## URGENT FIELD SAFETY NOTICE

### NOxBOXi Nitric Oxide Delivery Device (NOXBOX-I, UDI-DI: (01)05060541640009)

RE: NOxBOXi Nitric Oxide Delivery Devices, Rapid Succession of Conflicting User Inputs (Button Pushes)

# TECHNICAL BULLETIN

Fig. 1

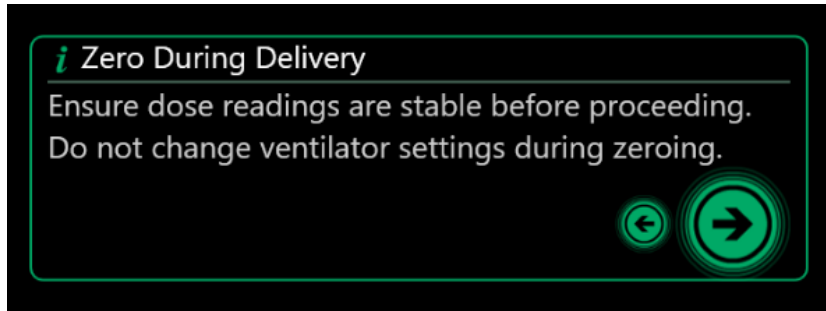
This issue may occur when two or more on-screen buttons are pressed by the user in a rapid succession (e.g., sensor zero, see Figure 1 below):

Users should avoid rapidly pressing buttons in quick succession (e.g., go to next screen, accept a value, change a value, backing out, repeating this) as it is necessary to allow an opportunity for the device to respond to user inputs before the next command to avoid a potential software interruption and subsequent restart.

Fig. 2

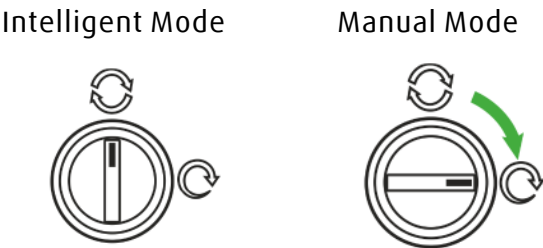
In the event of an unexpected NOxBOXi system restart while interacting with the device on screen prompts, the device will display the ‘System Diagnostics’ notification (see Figure 2 below). To continue therapy, the user should switch the device to Manual Mode from the Intelligent Mode to deliver Nitric Oxide (NO) via the NOxMIXER™ (manual mode, see Figure 3 below) and select the red on-screen ‘restart’ button.
